Item Name: Crosstube Assembly, Mid Aft

DART AEROSPACE LTD	Work Order: 98196
Description: Crosstube Assembly, Mid Aft	Part Number: D206-667-247TRN
Inspection Dwg: D206-667-247 Rev: A	Page 1 of 2

A	NEW ISSUE	CP	10.12.23
REV.	DESCRIPTION	BY	DATE
DESIGN	98	DART AEROSPACE LTD	
DRAWN	98	HAWKESBURY, ONTARIO, CANADA	
CHECKED	98	DRAWING NO.	REV. A
MFG. APPR.	98	D206-667-247	SHEET 1 OF 4
APPROVED	98	TITLE	SCALE
DE APPR.	98	CROSSTUBE ASSY (206L MID AFT)	NTS
DATE	10.12.23	COPYRIGHT © 2010 BY DART AEROSPACE LTD THIS DOCUMENT IS PRIVATE AND CONFIDENTIAL AND IS SUPPLIED ON THE UNDERSTANDING THAT IT IS NOT TO BE USED FOR ANY PURPOSE OR COPIED OR REPRODUCED IN ANY MANNER WITHOUT WRITTEN PERMISSION FROM DART AEROSPACE LTD

DRAWING NO. D206-667-247	TITLE CROSSTUBE ASS'Y (206L MID AFT)	REV. A	DART AEROSPACE LTD ENGINEERING ORDER		D.E.O. NO. D206-667-247-A-1	SHEET NO. SHEET 1 OF 1	SCALE NTS
DRAWN 92	CHECKED ASS	MFG. APPR. KD	APPROVED JMP	DE APPR. H			
DATE 11.07.15	DATE 11.07.20	DATE 11.07.21	DATE 11/07/21	DATE 11.07.21

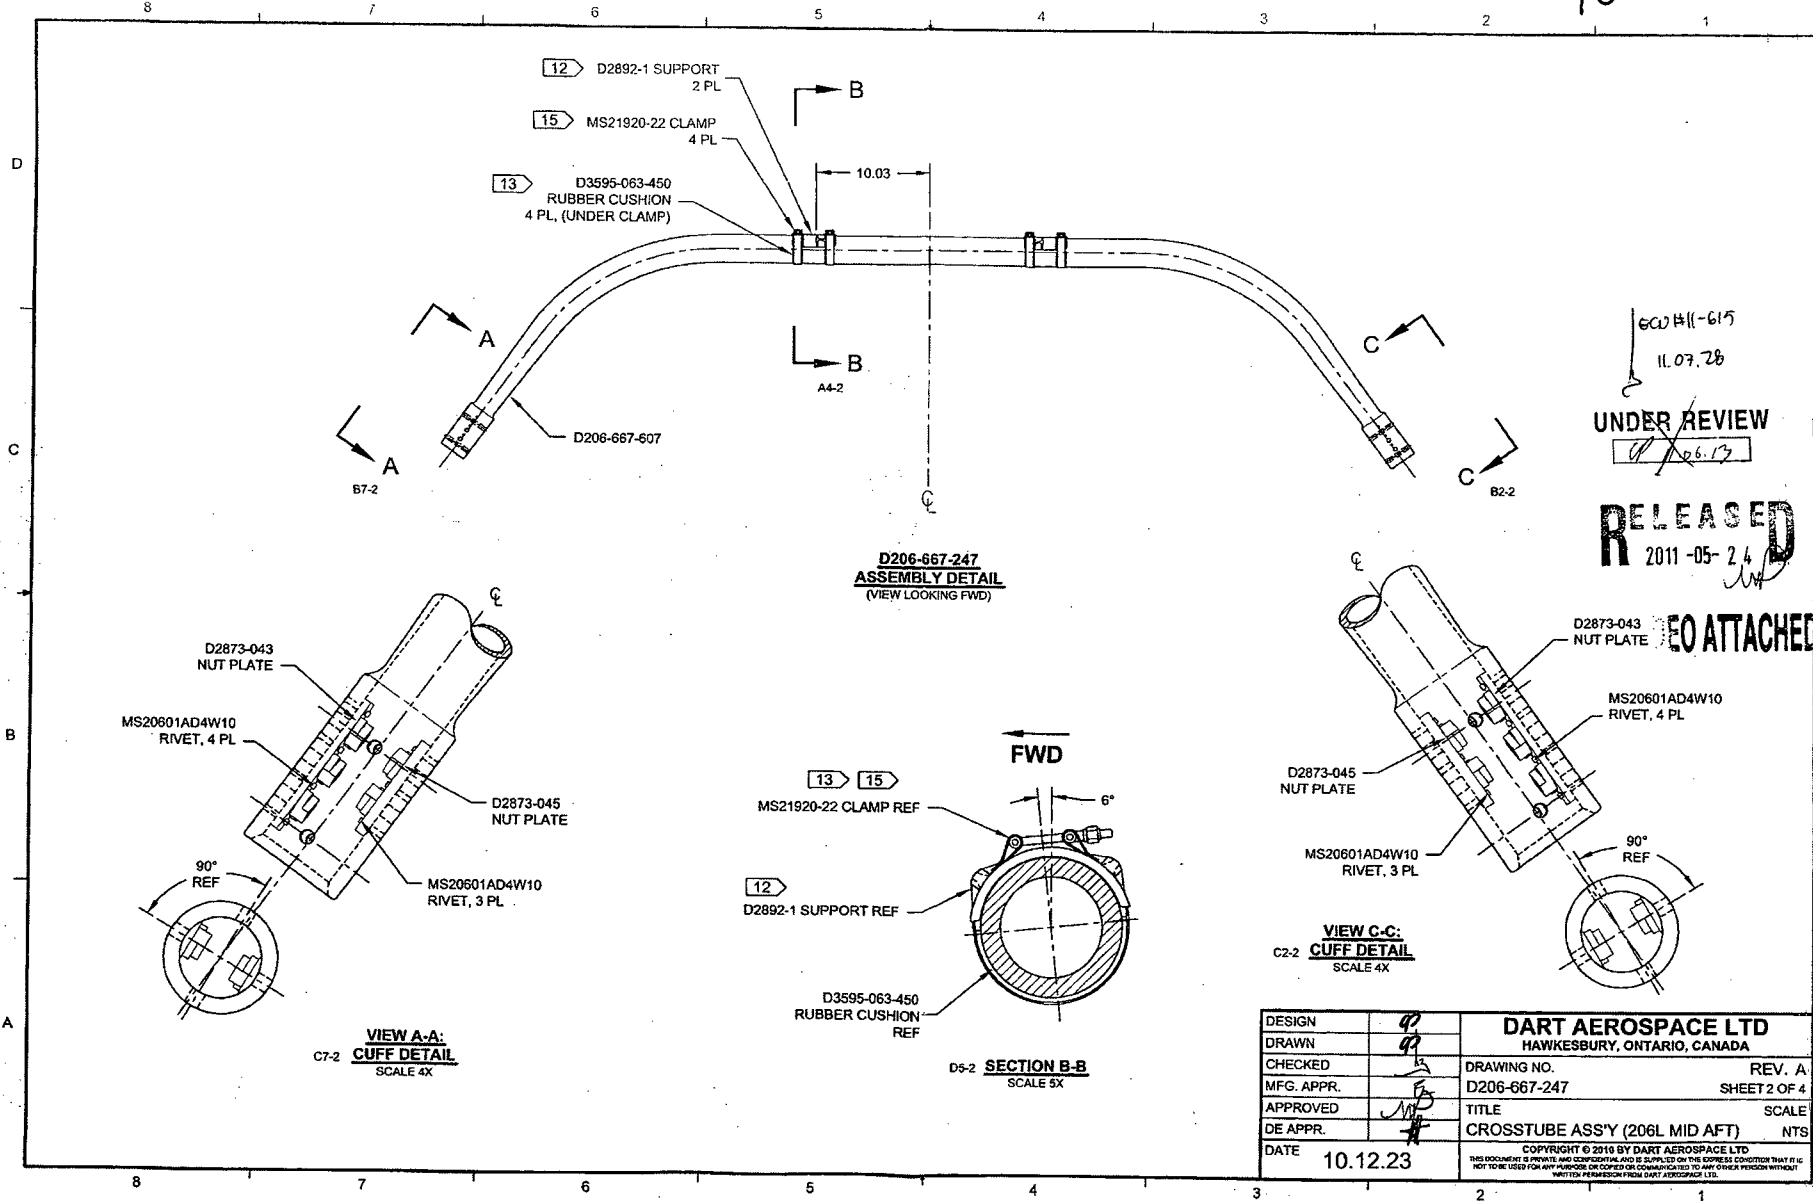
PURPOSE:

REPLACE MAGNOBOND WITH PROSEAL.

IS:

Item	Qty -247	Part Number	Description
9	A/R	PROSEAL 890 B-2	SEALANT, AMS-S-8802 CLASS B-2

WAS:

9	A/R	MAGNOBOND 6398	ROCKWELL SPECIFICATION RBO-120-023 ADHESIVE (TEXTRON/BELL SPEC. 299-947-100, TYPE II, CLASS 2 ADHESIVE)
---	-----	----------------	---

NOTE 12 & 15, SHEET 1 IS AMENDED AS FOLLOWS:

IS:

12) TO INSTALL D2892-1 SUPPORT: ABRABE MATING SURFACE OF SUPPORT AND CROSSTUBE WITH 180-GRIT SANDPAPER AND REMOVE RESIDUE WITH MEK (OR EQUIVALENT). APPLY A 0.04" TO 0.07" THICK LAYER OF PROSEAL 890 CLASS B-2 (OR AMS-S-8802 CLASS B-2) SEALANT TO MATING SURFACE OF SUPPORT.

15) TORQUE CLAMPS 80 TO 100 IN-LB. ENSURE AT LEAST 1.5 THREADS SHOWING IN SAFETY AND THAT NUT HAS NOT BOTTOMED-OUT AFTER TORQUING. **PRIOR TO PACKAGING, RE-CHECK TORQUE ON CLAMPS AFTER PROSEAL 890 SEALANT HAS CURED FOR 72 HOURS.**

WAS:

12) INSTALL D2892-1 SUPPORT USING 0.03" TO 0.06" THICK LAYER OF MAGNOBOND 6398 PER QSI 015. LET CURE FOR 12 HOURS AFTER INSTALLATION AND PRIOR TO PACKAGING.

15) TORQUE CLAMPS 80 TO 100 IN-LB. ENSURE AT LEAST 1.5 THREADS SHOWING IN SAFETY AND THAT NUT HAS NOT BOTTOMED-OUT AFTER TORQUING.
